**ADDENDUM #5
FORMAL BID 2022-104**

**KITSAP COUNTY PUBLIC WORKS WASTEWATER DIVISION
BANGOR-KEYPORT FORCE MAIN REPLACEMENT**

April 11, 2022

**FORCE MAIN REPLACEMENT
PLAN & PROFILE STA 42+00
TO STA 47+40
SCHEDULE A**

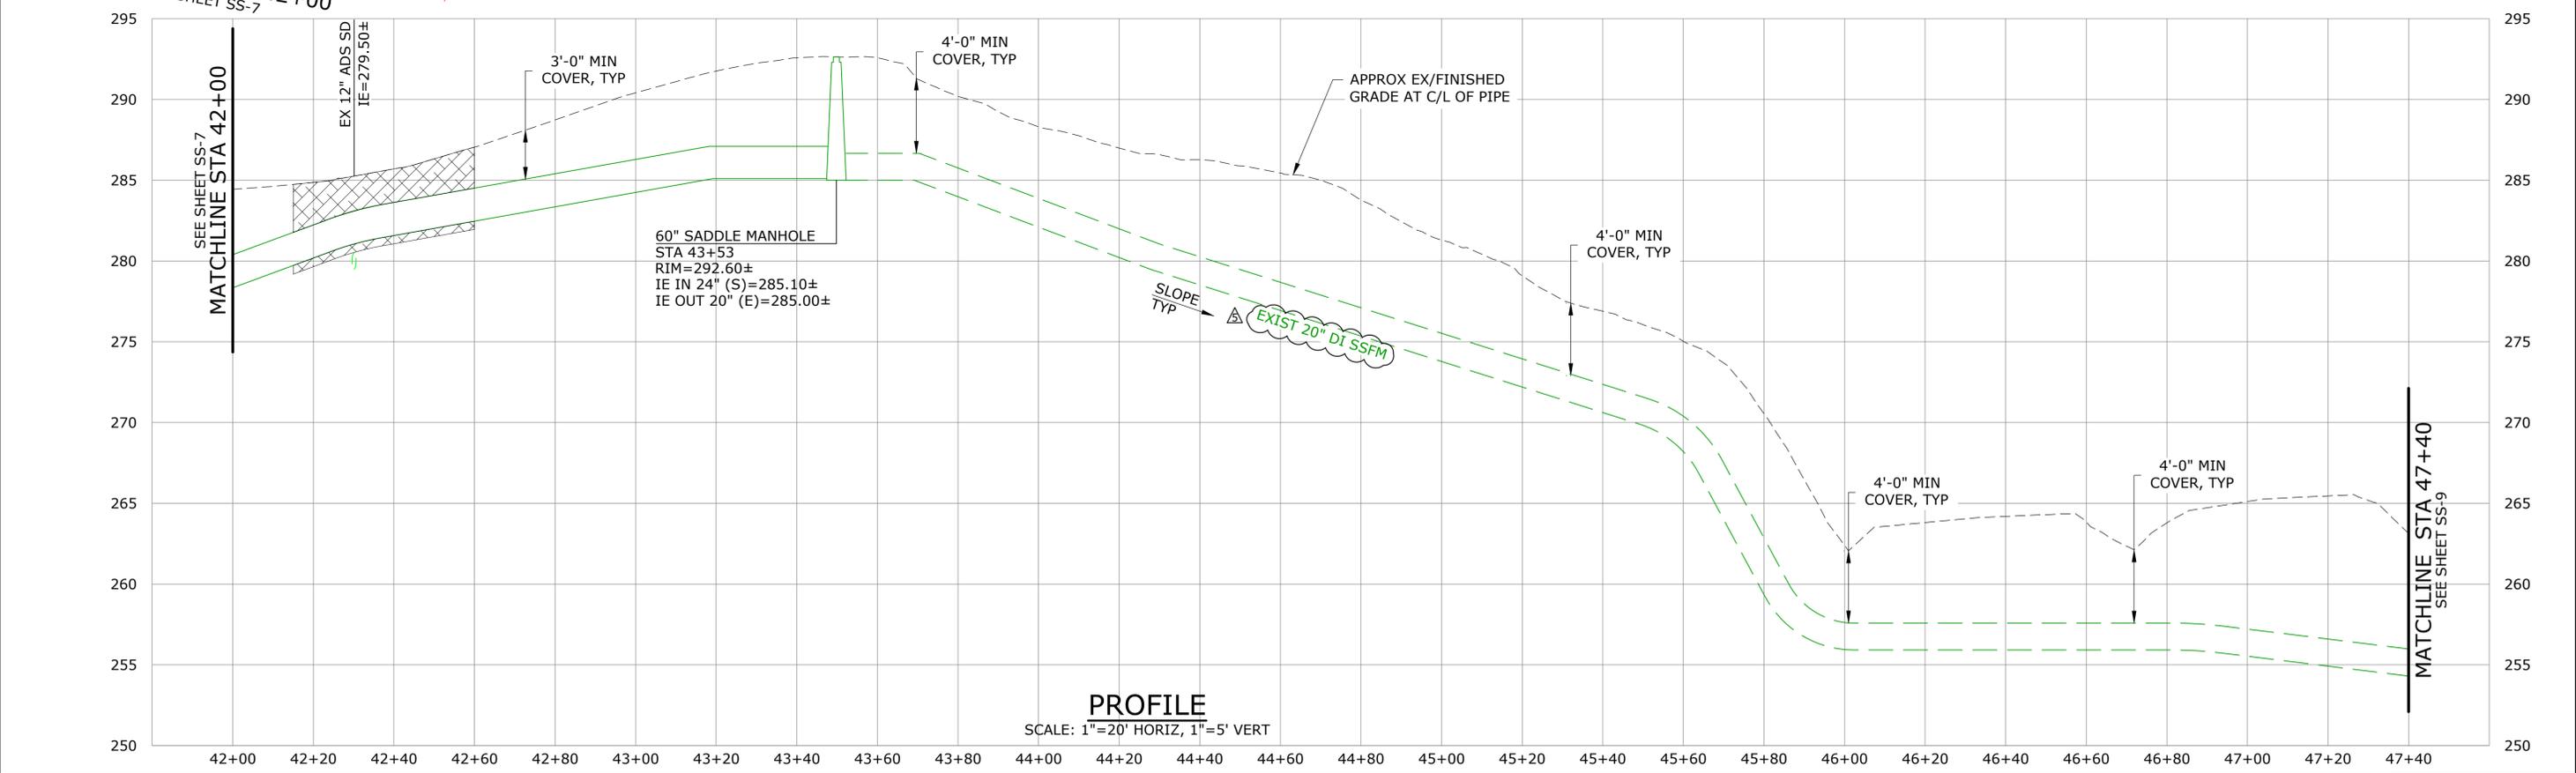
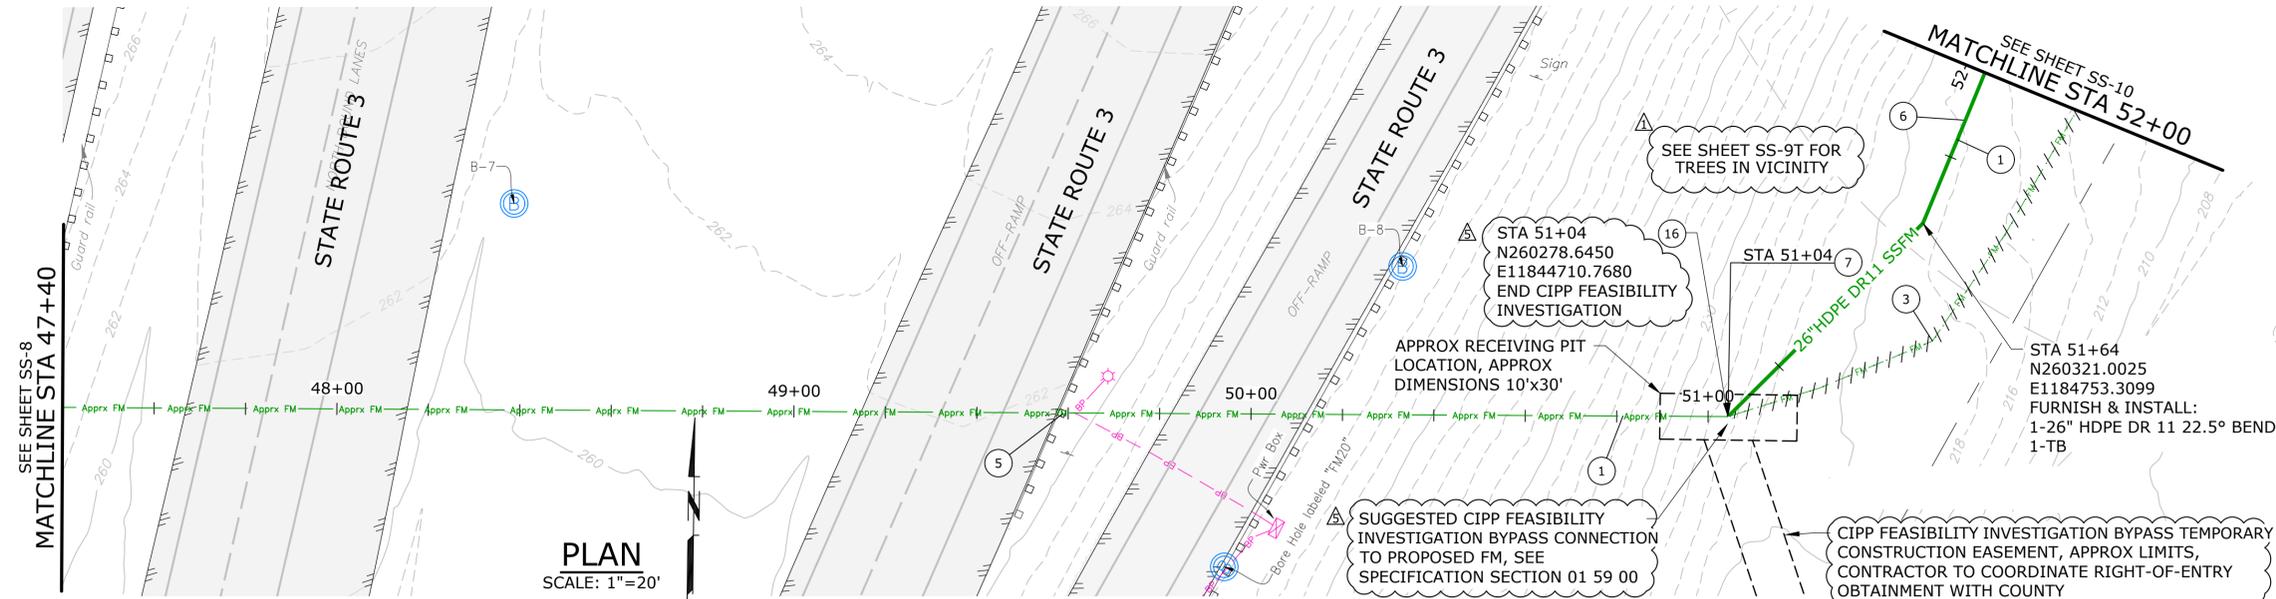
Item 10. REMOVE sheet SS-8 and REPLACE with attached sheet SS-8.

2. BEND PIPE TO ACHIEVE DESIRED ALIGNMENT AND NOT TO EXCEED MINIMUM ALLOWABLE BENDING RADIUS, PER MANUFACTURER RECOMMENDATIONS.
 3. TEMPORARY BYPASS SSFM FOR CIPP FEASIBILITY INVESTIGATION PER SPEC 01 59 00.

- 6 SS FM TRENCH SECTION PER DET 3, SHT SS-58
 - 7 FURNISH & INSTALL TRACER WIRE AND HANDHOLE PER DET 1, SHT SS-58
 - 15 PERFORM CIPP FEASIBILITY INVESTIGATION OF EXIST 20" DI FM, SEE NOTE 3, THIS SHT

**FORCE MAIN REPLACEMENT
PLAN & PROFILE STA 47+40
TO STA 52+00
SCHEDULE A**

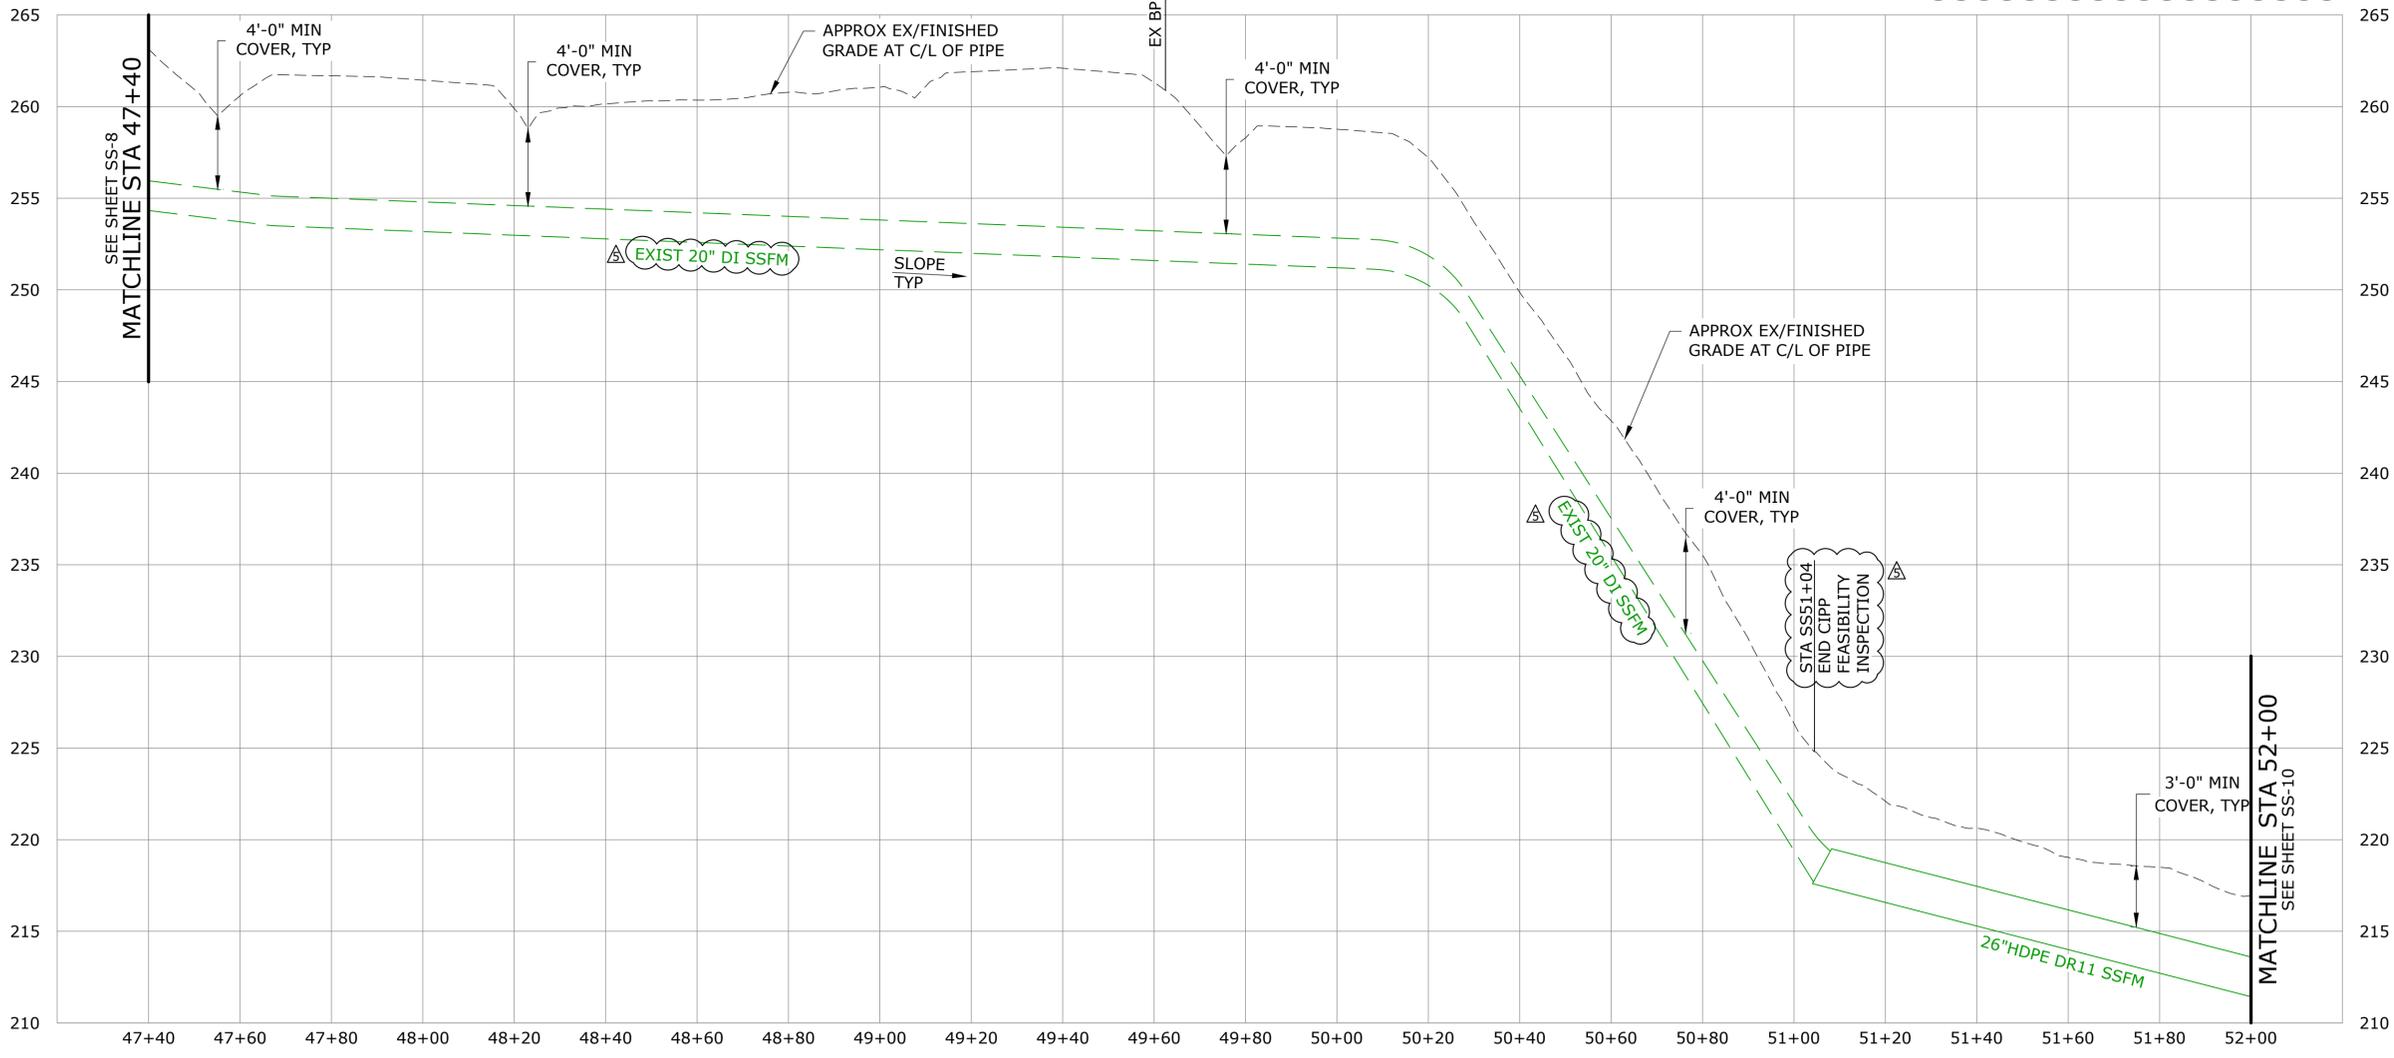
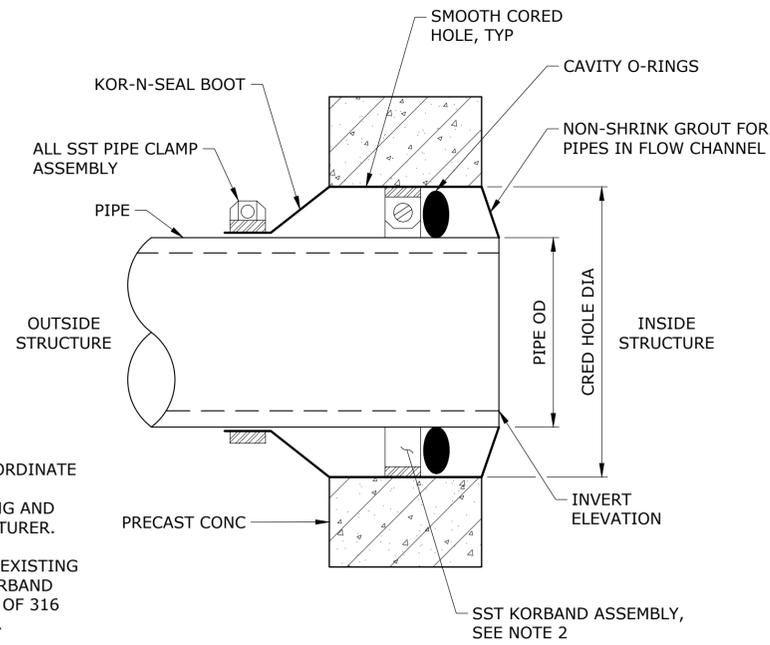
Item 11. REMOVE sheet SS-9 and REPLACE with attached sheet SS-9.

- CONSTRUCTION NOTES:**
- 1 CONSTRUCTION CL EQUALS PROPOSED PIPE CL, SEE SURVEY CONTROL PLAN, SHT G-5
 - 3 ABAND EXIST SS FM & APPURTENANCES IN ACCORDANCE W/ SPECS
 - 5 PROTECT EXIST UNDERGROUND POWER AND TELECOMMUNICATION, DURING CONSTRUCTION
 - 6 SS FM TRENCH SECTION PER DET 3, SHT SS-58
 - 7 FURNISH & INSTALL TRACER WIRE AND HANDHOLE PER DET 1, SHT SS-58
 - 16 TRANSITION FROM EXIST 20" DI SSFM TO 26" HDPE DR 11 PIPE, SEE DET 4, SHT SS-60

**SCHEDULE A & SCHEDULE B
MISCELLANEOUS SEWER
DETAILS - 4**

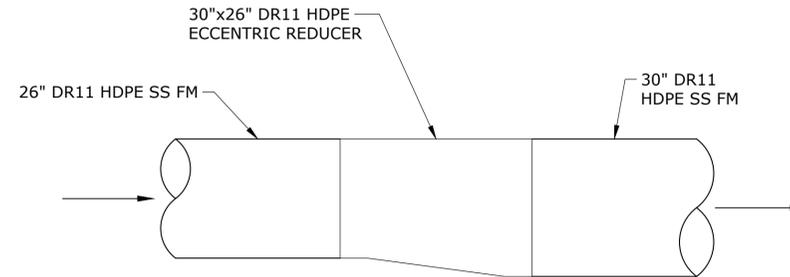
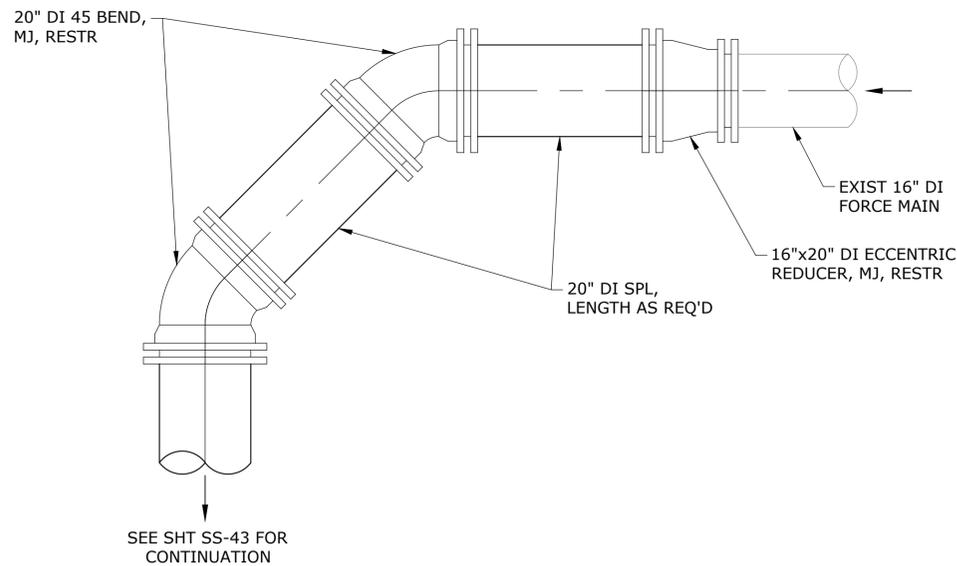
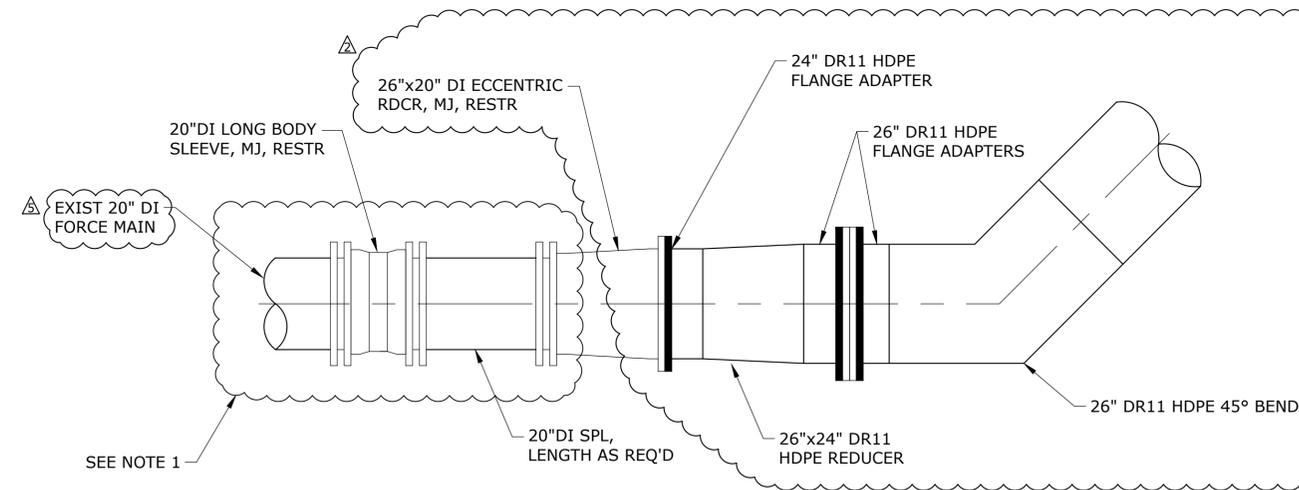
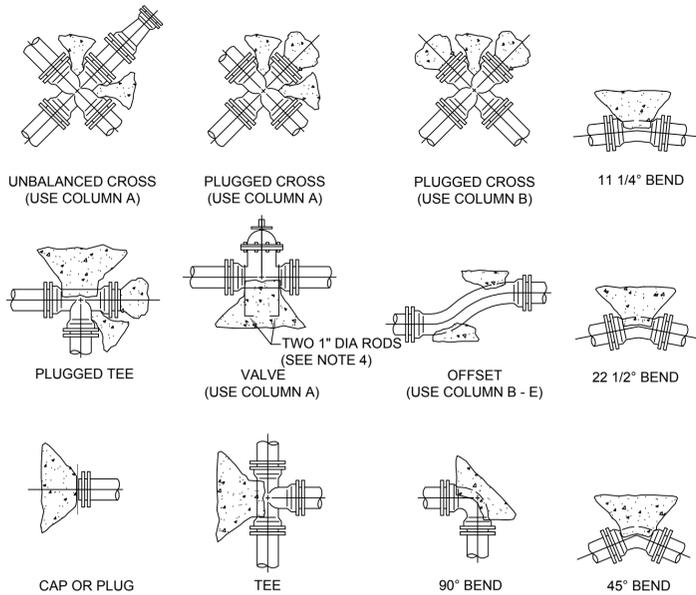
Item 12. REMOVE sheet SS-60 and REPLACE with attached sheet SS-60.

1. SEE DETAIL 3, ON SHEET SS-61 FOR CIPP END CONNECTION.

MISCELLANEOUS SEWER DETAILS - 5

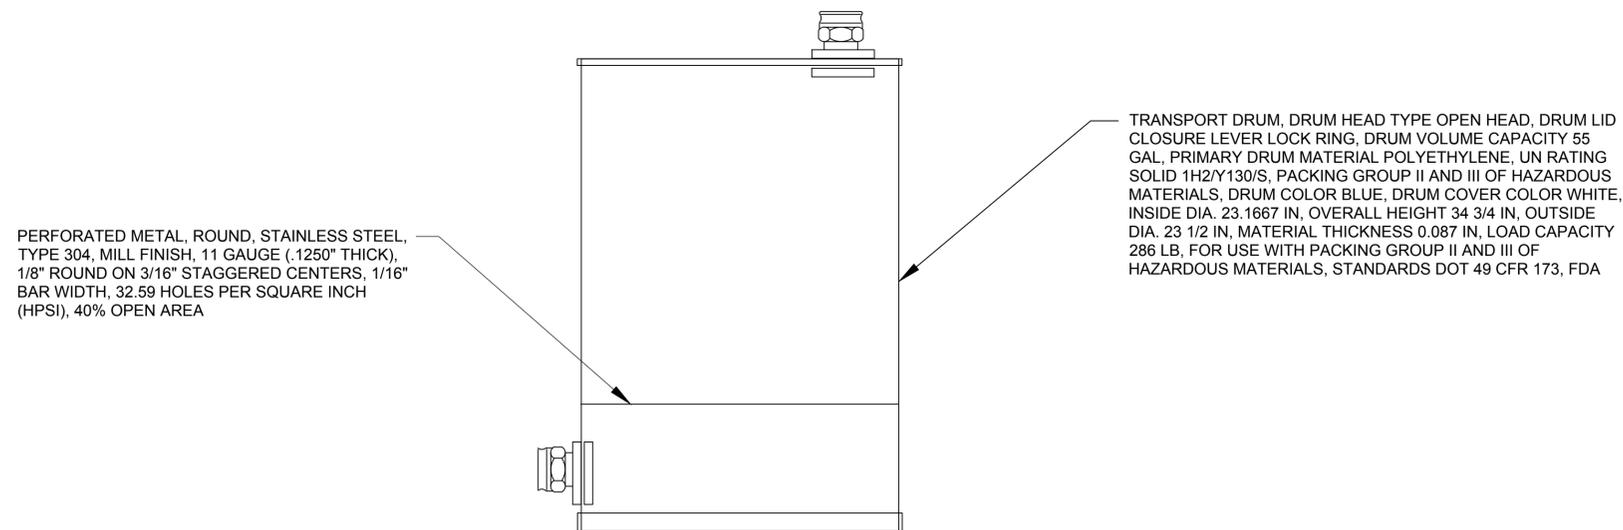
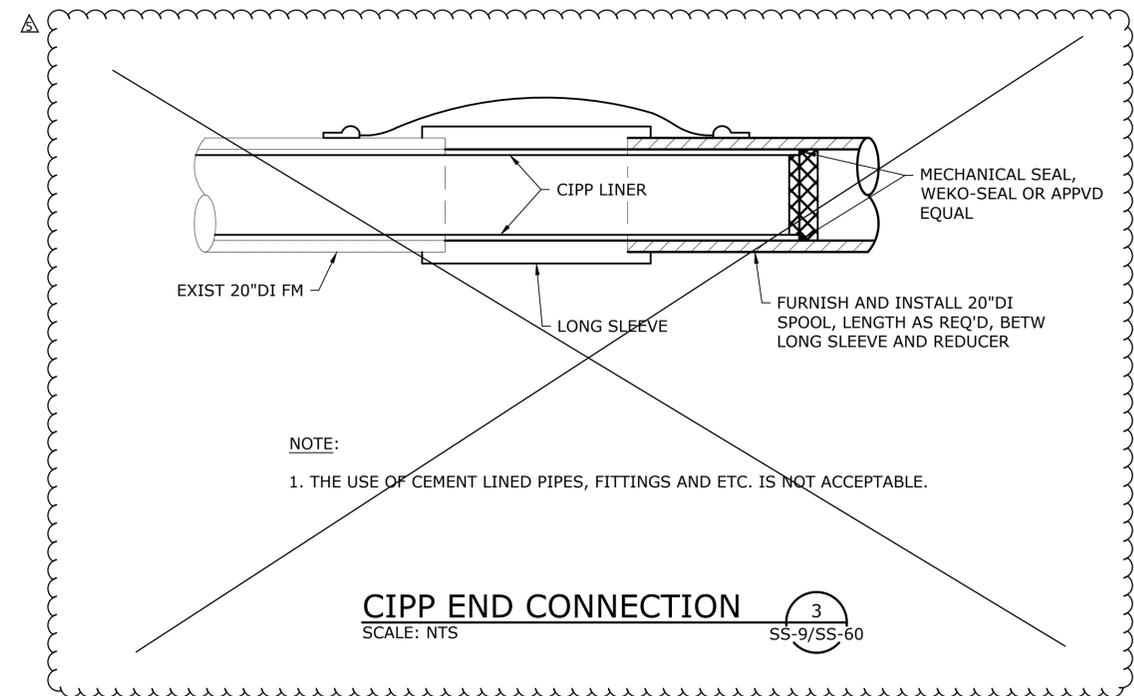
Item 13. REMOVE sheet SS-61 and REPLACE with attached sheet SS-61.
